Type 3/4 PSEs Inrush_max value with Type 1/2 PDs

IEEE802.3bt

September 2015

Rev 003

Proposed Changes for D.12

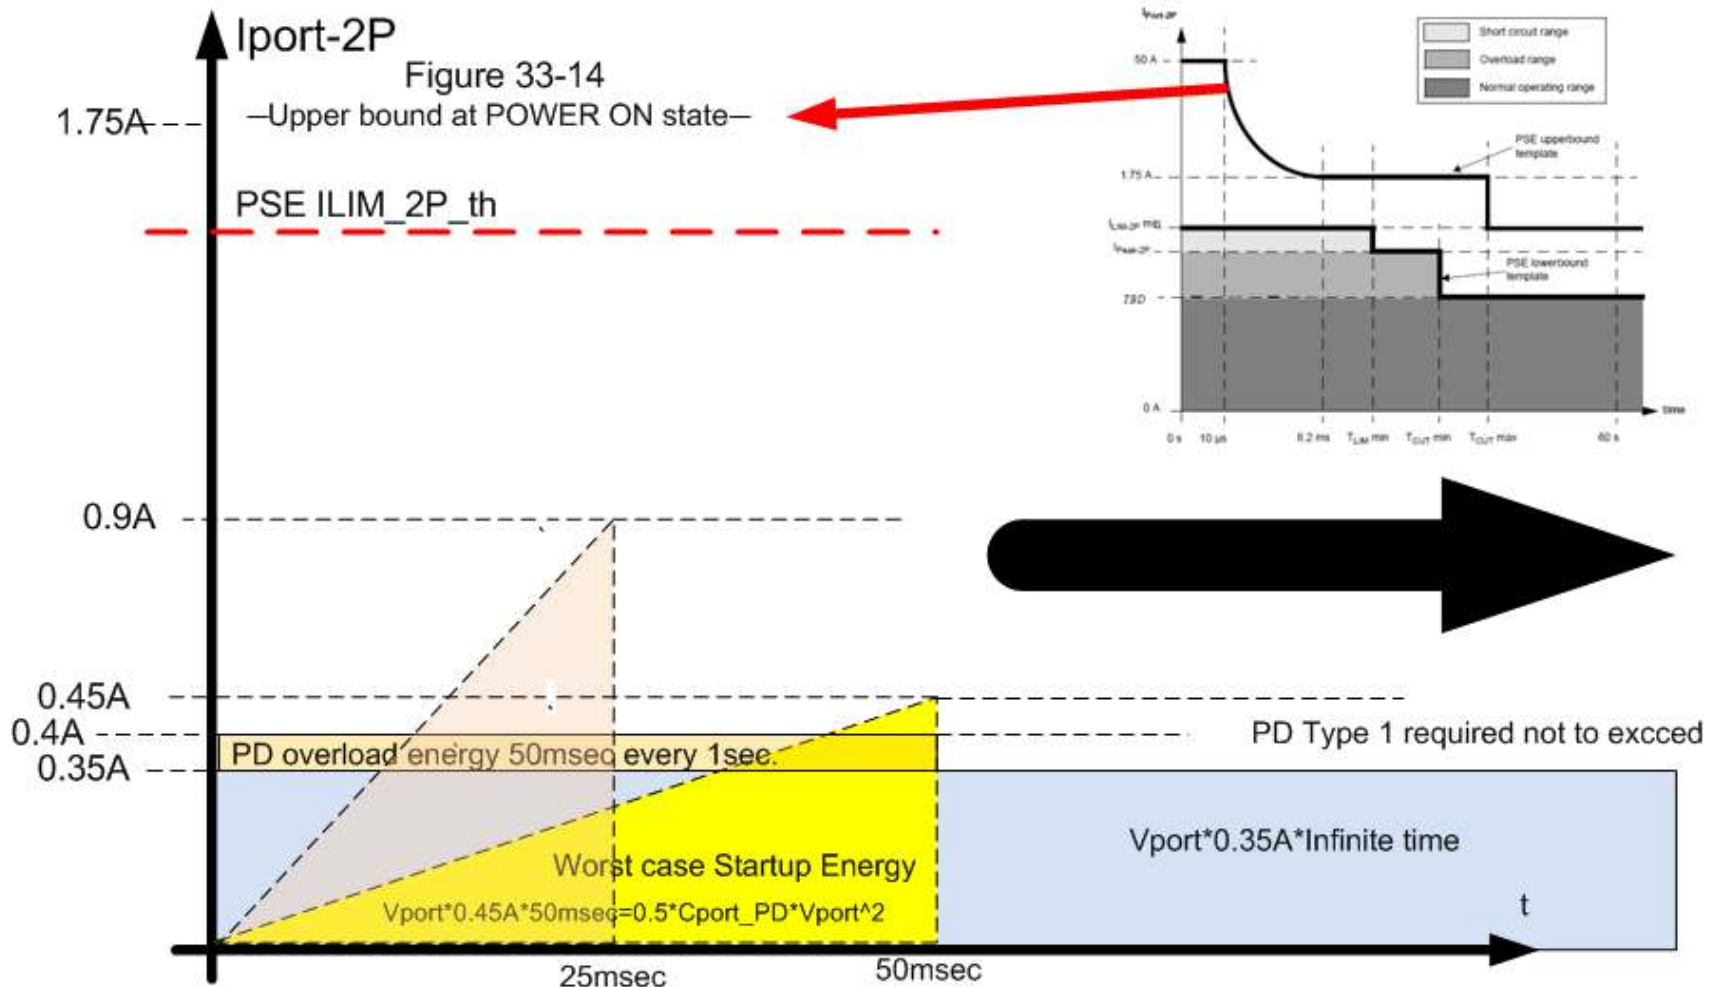
- System vendors do not want to be liable for poorly designed PD or non compliant PDs
- Therefore, Type 3 and 4 PSEs supplying 0.4A-0.45A to Type 1/2 PDs could be a feature but can not be mandatory. PD need to be designed to handle higher than 0.9A anyway.

#	Parameter	Symbol	Units	Min	Max	PSE Type	Additional Information
5	Output current in POWER_UP state	I _{nrush}	A	0.4	See Info	1,2,3,4	For Type 1 and Type 2 PDs. See 33.2.7.5. Max value defined by Figure 33-13.

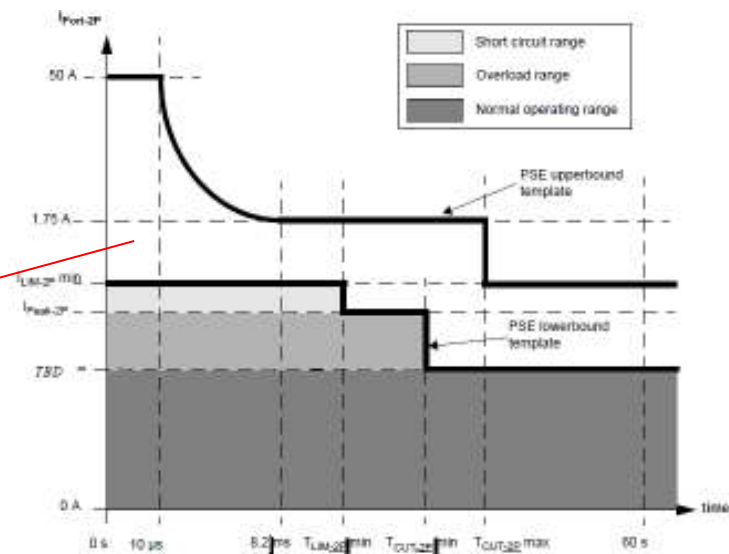
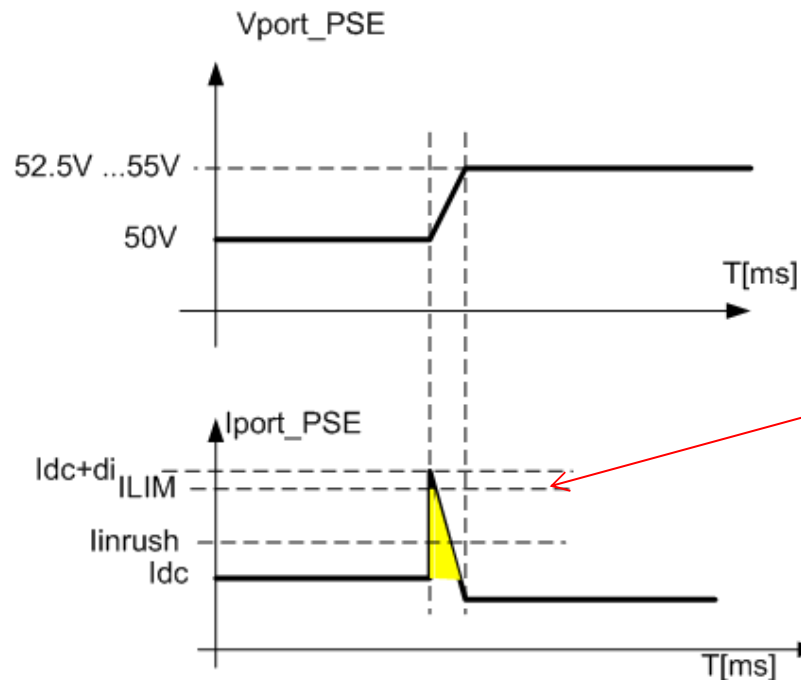
- **IEEE** (Need to be guaranteed by PD at all times):
 - Type 1: Not to consume more than 0.4A for more than 50msec.
 - Type 2: Not to consume more than $\sim 0.6A \cdot 1.14$ for more than 50msec
 - All types: to meet PSE dv/dt that will generate $I_{peak}=2.5A$ and will be limited by PSE ILIM.
